VILLAGE PLAN COMMISSION AGENDA

Tuesday, July 15, 2025 at 5:00pm
Rick J. Hermus Council Chambers
515 W. Kimberly Ave.
Kimberly, WI 54136

ITEM DESCRIPTION: Site & Architectural Review – Gathering Hub located at 728 Schelfhout Lane
REPORT PREPARED BY: Sam Schroeder, Community Development Director
REPORT DATE: July 15, 2025
<p>EXPLANATION: MJI Building Services on behalf of the Gathering Hub has submitted a site review application to convert the former Footworks Dance Company building located at 728 Schelfhout Lane into an event space. The property was purchased by the current owner on May 28, 2025, who intends to operate her own event venue being the Gathering Hub. Around the time the property was acquired, the owner had reached out to apply for a liquor license. Upon this contact and information from the Clerk’s office, the Village staff sat down with the owner of the property, realtor, and architect to discuss the proposed project, business plan, concerns, in addition to the approval process.</p> <p>The venue will include a large and smaller gathering space, enlarged restroom facilities, an office, and a food prep room. No food would be made on-site. Based upon the square footage,

DEMOLITION AND NEW PLANS

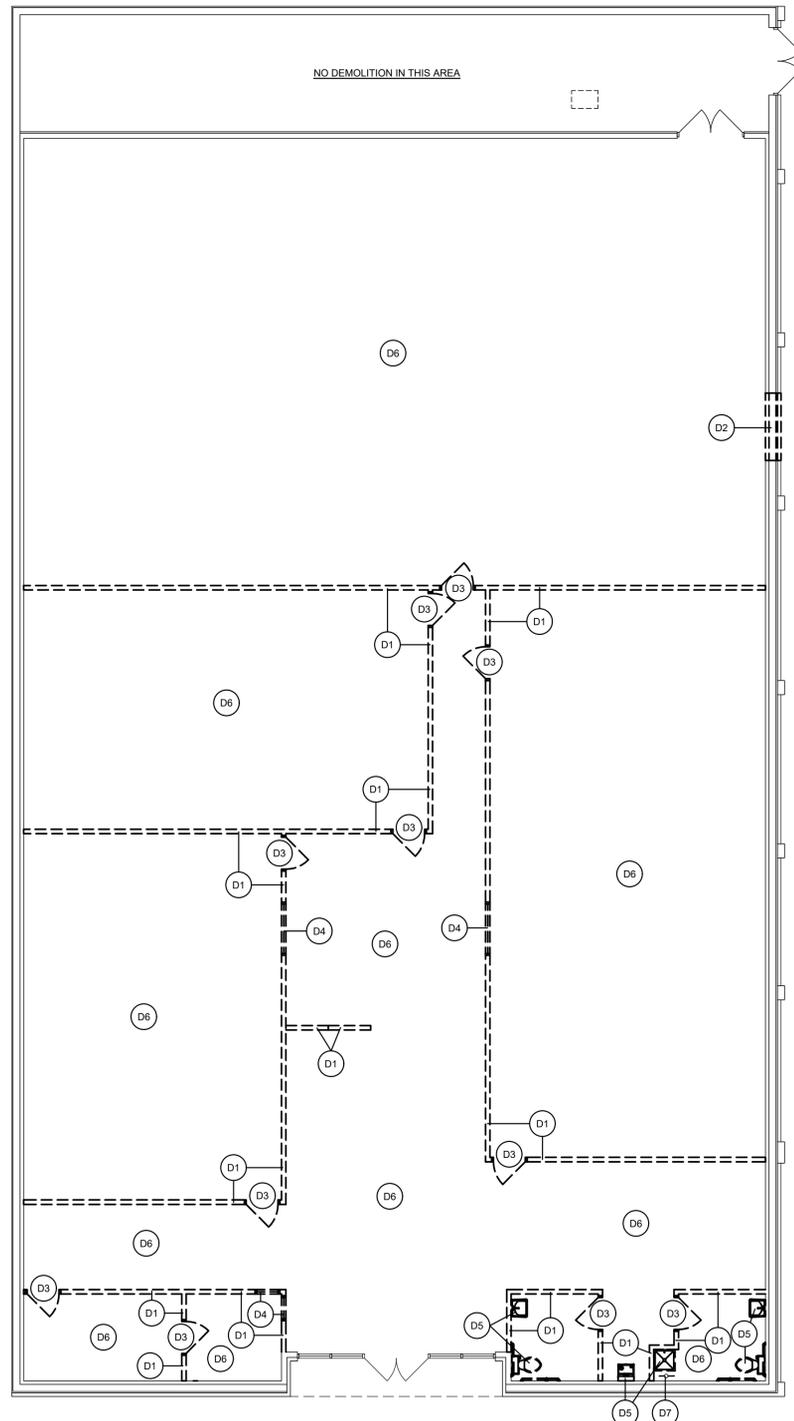
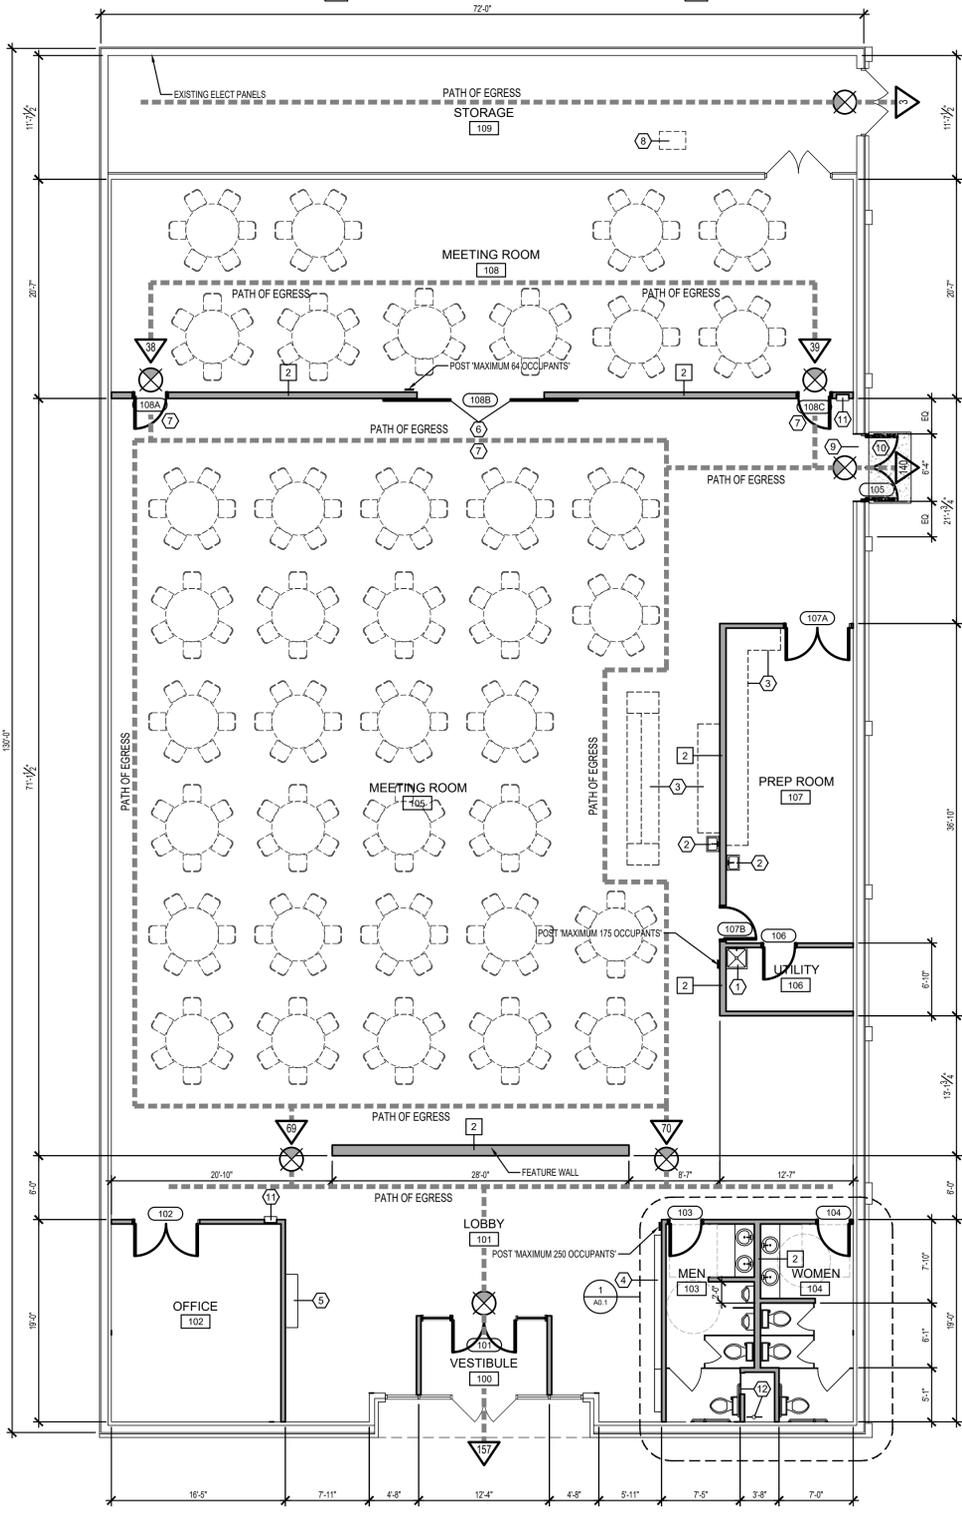
2. **Noise.** Due to the proximity of this event venue to the residential properties to the west, there is a concern that noise could travel through the building and impact surrounding neighboring homes. Staff is recommending considerations for noise dampening material to be used throughout the buildout of the interior as well as the landscaping to the west to be maintained.
3. **Lighting.** Any upgrades to lighting shall be full cut off and meet code.
4. **Building Inspections and Approvals.** Building plan review and inspections will be completed by the Village of Kimberly. All necessary permits shall be applied for prior to additional work being done.

RECOMMENDED ACTION: Staff recommends approval of the site plan and architectural components for the Gathering Hub located at 728 Schelfhout Lane as presented, contingent upon the following:

1. A letter from MSA or the Fire Department is provided accepting a reduced occupancy shall be provided.
2. Occupancy shall be reduced to 200 (37 on-site stalls plus half of the 7 shared stalls divided by 20% similar to Community Center Use) or an official agreement acceptable to the Village staff shall be provided with a neighboring property for a minimum of 10 parking stalls at 250 occupancy load or more if exception is not granted in order to meet the max occupancy load.
3. Noise dampening materials shall be considered in the buildout of the interior as well as the landscaping along the western property line shall be maintained.
4. Any outdoor lighting improvements shall be full cut off and meet code.
